CONDITIONS OF APPROVAL:

Engineering - Final Plat Checklist

8. 0. General Information

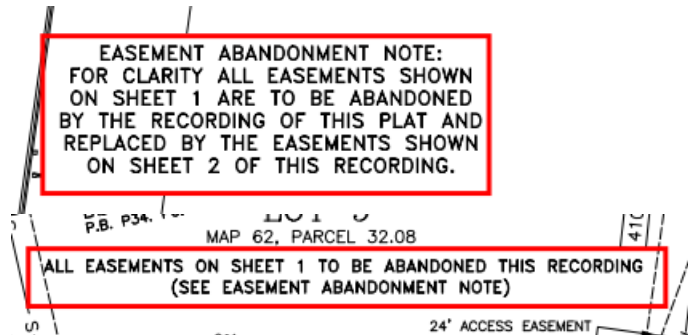
joe.marlo@franklin.tn.gov *Comment to remain open while COF 6512 is still under review.*

Applicant shall ensure that modifications to the site plan (COF 6512), which is being reviewed concurrently with this final plat, are reflected on the final plat. The final plat shall match the site plan, including all easement modifications requested on the associated site plan submittal.

10. Existing Easements

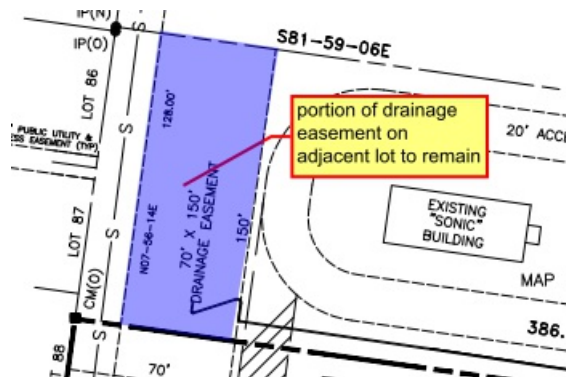
Easements on Lots other than Lot 9 cannot be deleted with this plat. Applicant to revise plat as follows:

1. Revise notes noted below clarifying that only Lot 9 easements are to be abandoned.

2. Show the portion of the drainage easement in the back of Lot 5 on Sheet 2 of 2, as this portion is not being abandoned. On Sheet 2, Applicant to revise the "70' x 150' Drainage Easement" call-out for this easement to state "Drainage Easement P56, PG. 126".

12. C. Final Plat

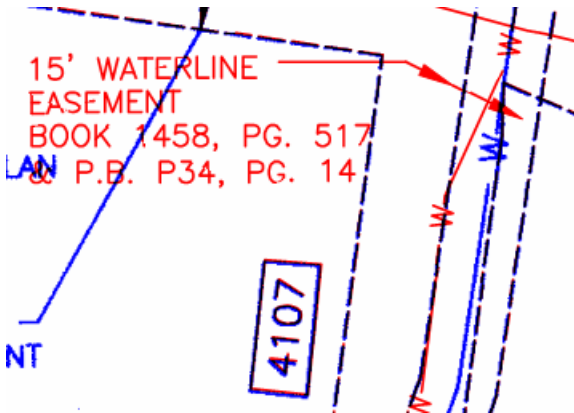
joe.marlo@franklin.tn.gov Comment not adequately addressed. Old plat reference is still shown on north arrow on Sheet 1 and north arrow has now been deleted on Sheet 2.

Remove North Arrow reference to a plat that, with the recording of this plat, will be two revisions back. Provide North Arrow on Sheet 2.

23. C. Final Plat

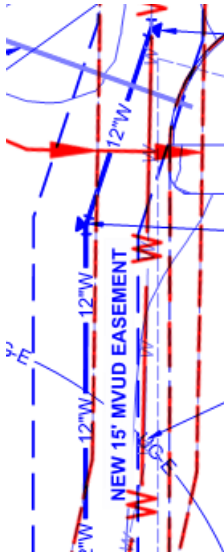
1. The existing waterline location and arrow leaders from easement call-out on Sheet 1 of 2 are incorrect (previous plat in blue, proposed plat in red). Applicant to correct on plat.

2. The proposed waterline location and easement shown on Sheet 2 of 2 does not match the location shown on Site Plan C5.0 (COF 6512) (Site Plan in blue, proposed plat in red). Applicant to correct on plat.

24. C. Final Plat

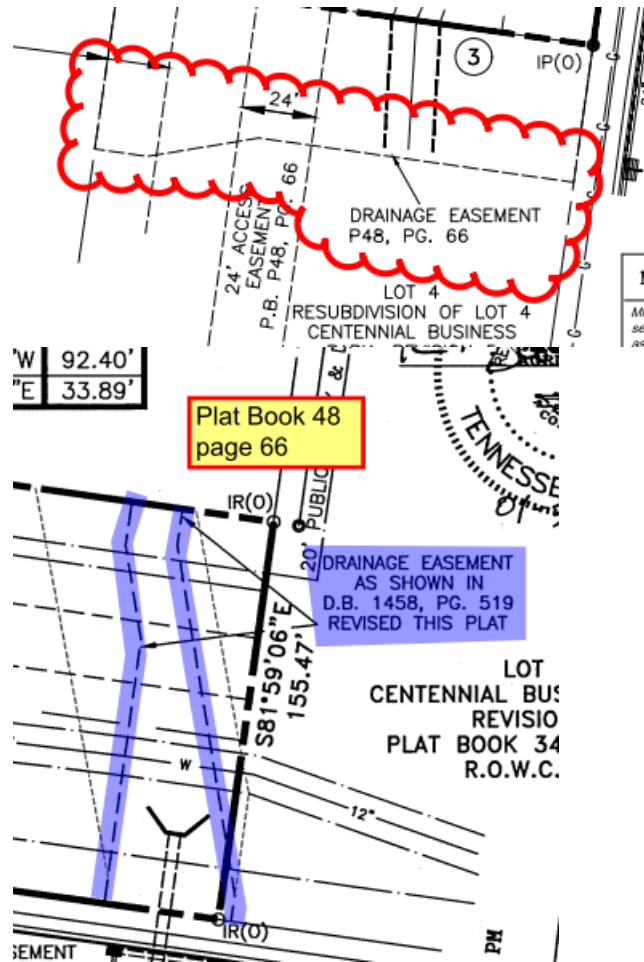
Delete extraneous call-out and arrows shown below from Sheet 1.
